SERVICE BULLETIN

No. 193

Piper Aircraft Corporation

SUBJECT: Modification of Fuel Cell Vent Tube

FUEL CELL VENT TUBE

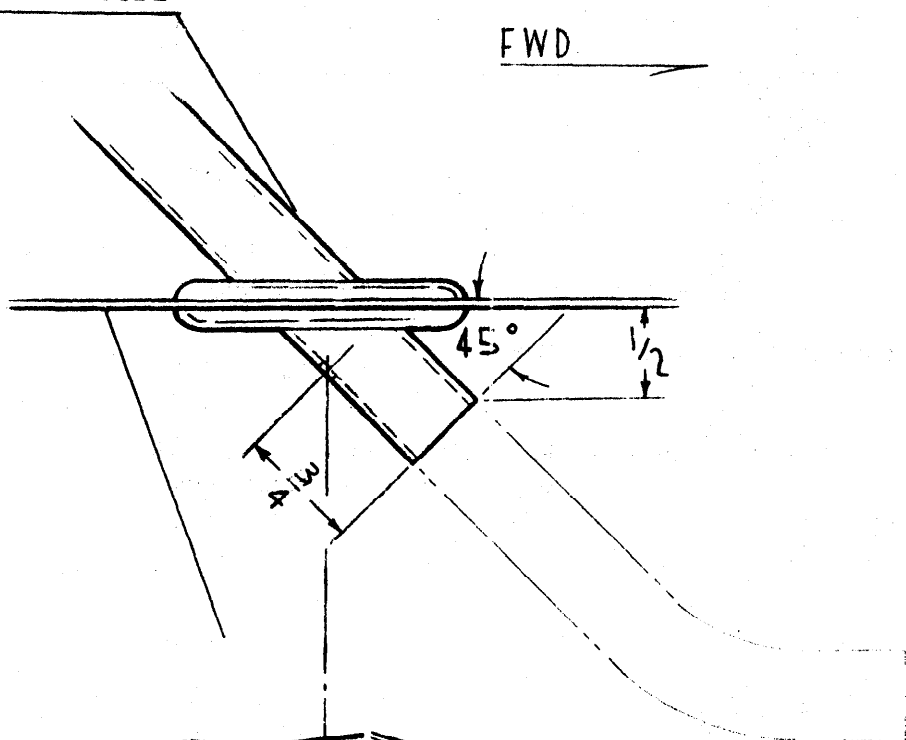
A .098 hole is to be drilled in each of the vent tubes as shown on the sketch on the reverse side of this bulletin.

This modification will minimize the possibility of any interruption of the fuel flow in the event that the opening of the vent tube should become obstructed.
